PUBLIC IMPROVEMENT CONSTRUCTION PLANS
LOT 6G-3A-3, THE MEADOWS FILING NO. 17, AREA NO. 4, AMENDMENT NO.17,
SITUATED IN THE NORTHWEST QUARTER OF SECTION 34, TOWNSHIP 7 SOUTH, RANGE 67 WEST OF THE
6TH P.M., TOWN OF CASTLE ROCK, COUNTY OF DOUGLAS, STATE OF COLORADO
CD24-0008 & FCO25-0001

FIELD CHANGE ORDER TABLE		
FCO#	DATE	PURPOSE/DESCRIPTION
FCO25-0001	2/21/2025	PRIVATE WATERMAIN RECONFIGURATION

CONSTRUCTION DOCUMENTS	COVER SHEET
LITTLE SUNSHINE'S PLAYHOUSE & PRESCHOOL	
PRAIRIE HAWK DRIVE AND LIMELIGHT AVENUE	
PROJECT NO:	
DESIGNED BY:	LCG
DRAWN BY:	LCG
DATE:	06/28/2024
C0.0	
SHEET 1 OF 22

UTILITY PLAN

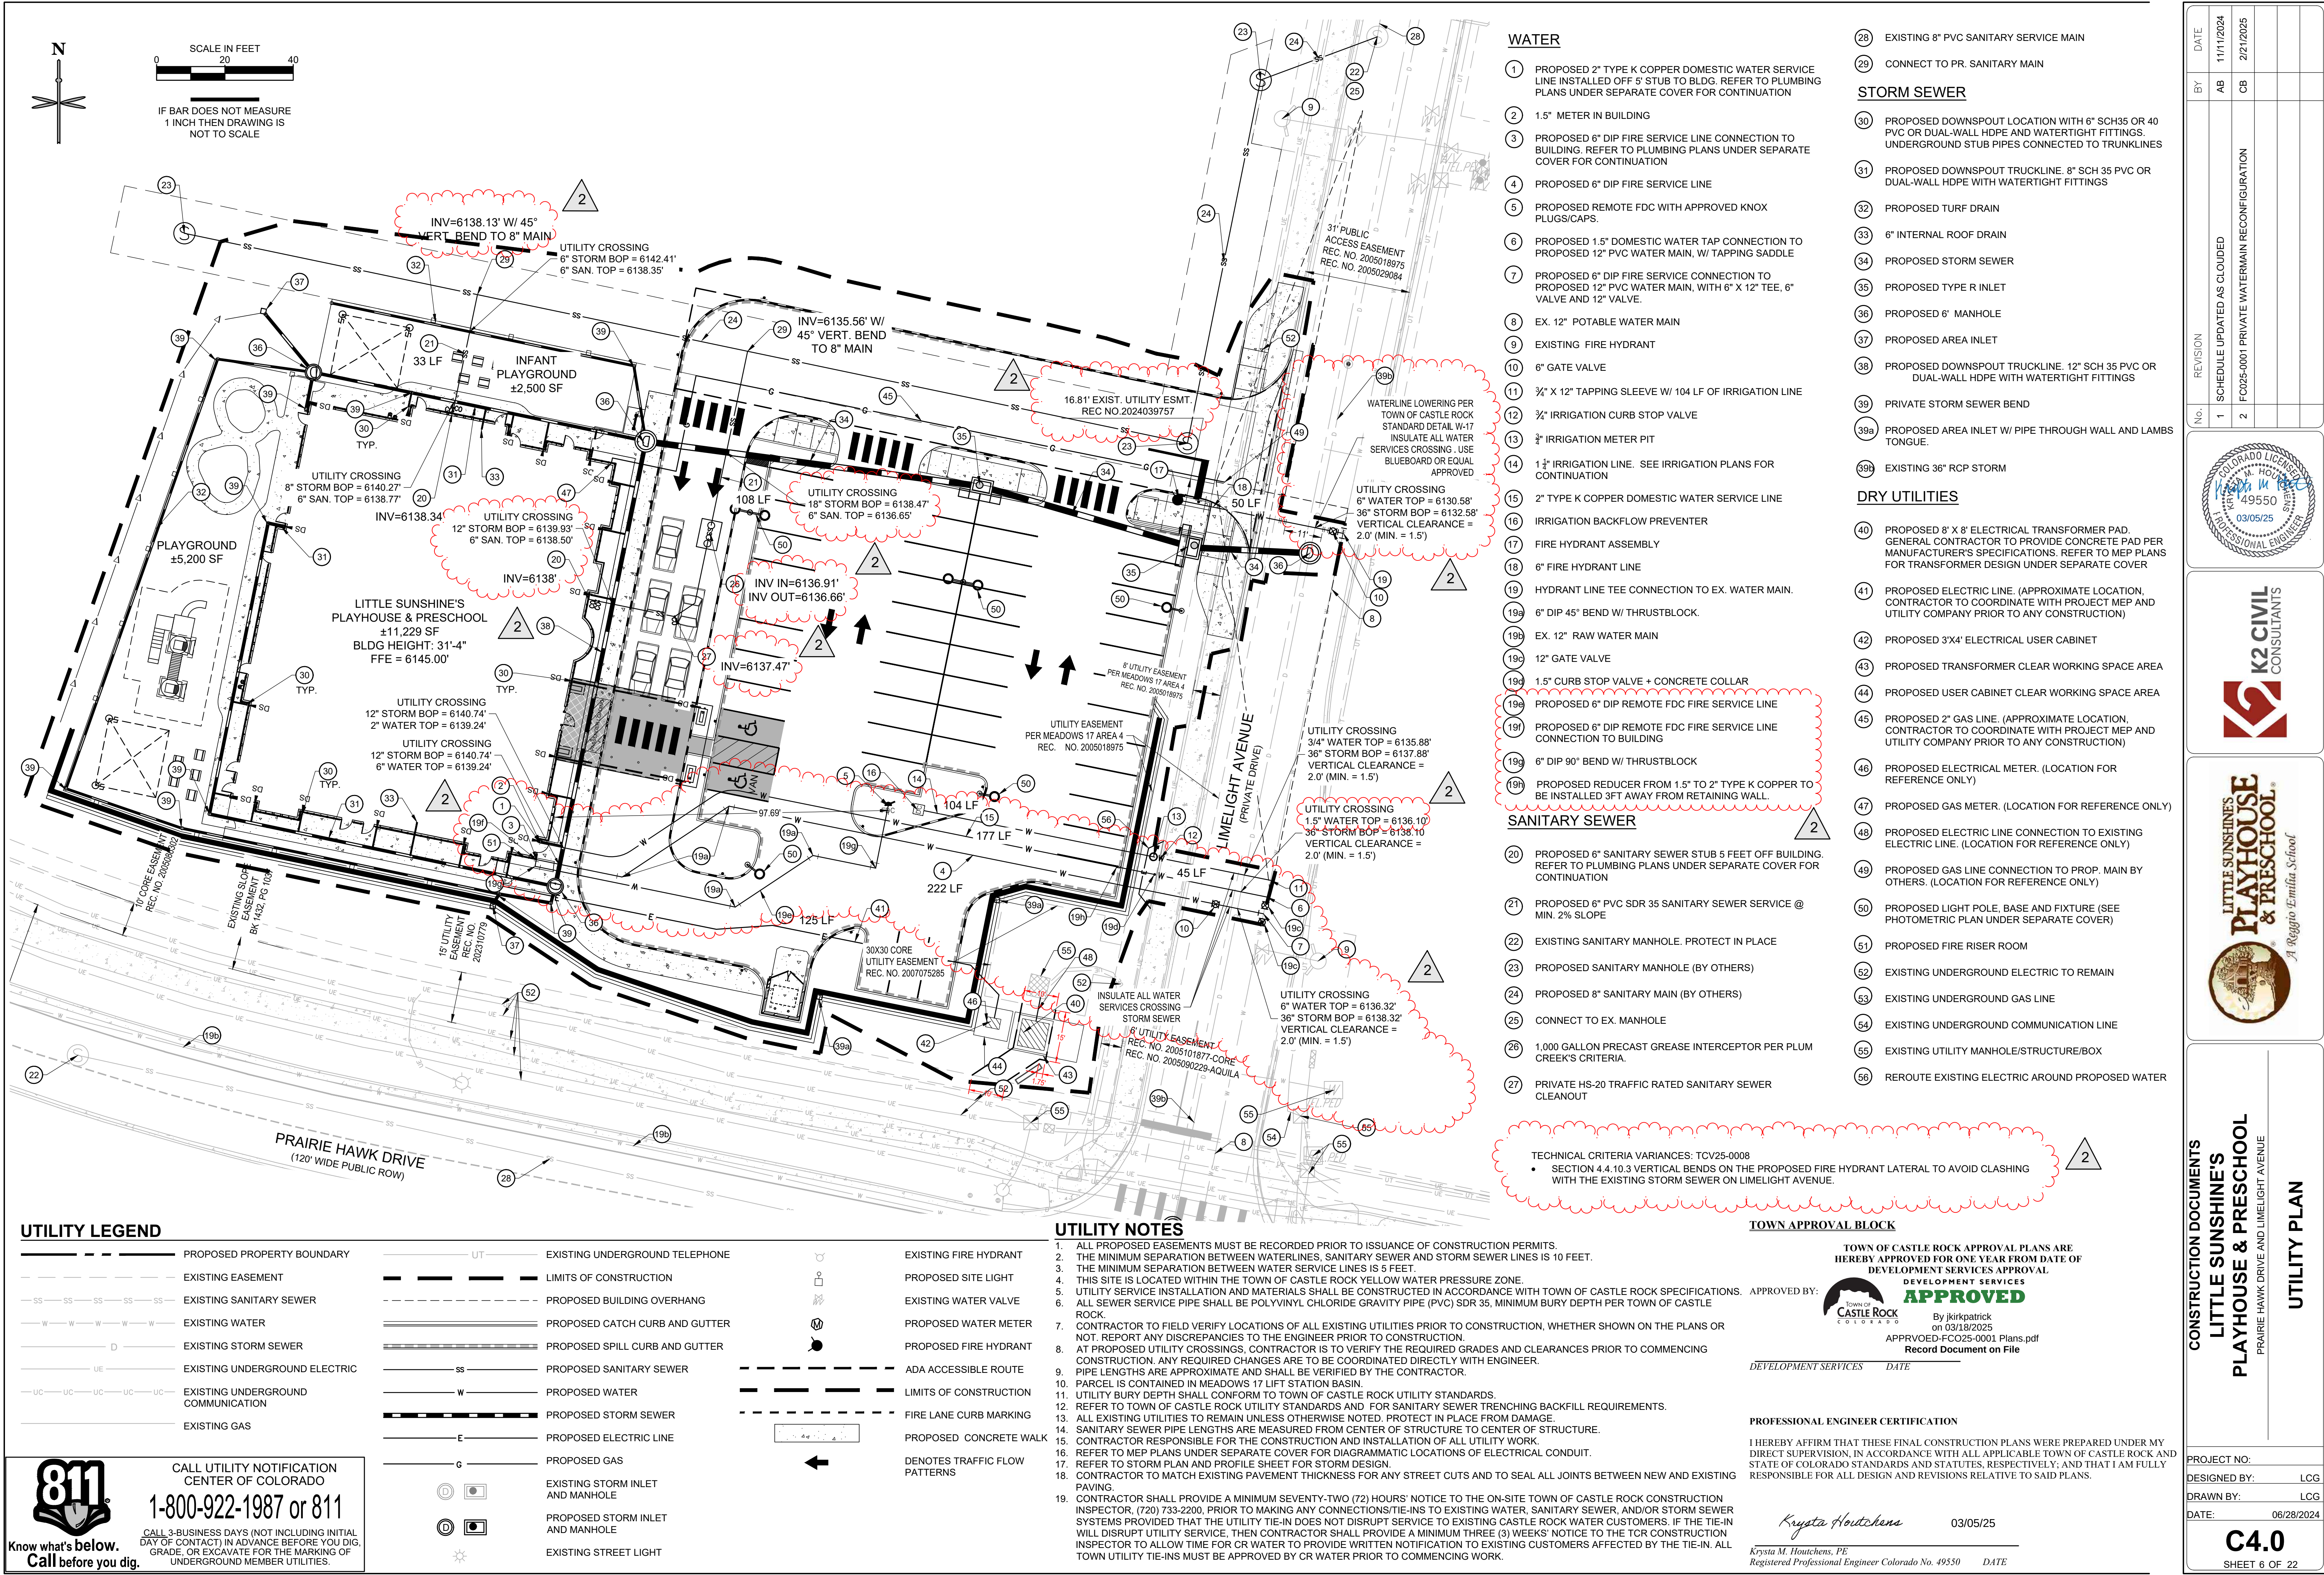
DATE	11/11/2024
BY	AB CB
REVISION	1 SCHEDULE UPDATED AS CLOUDED
No.	2 FC025-0001 PRIVATE WATERMAIN RECONFIGURATION
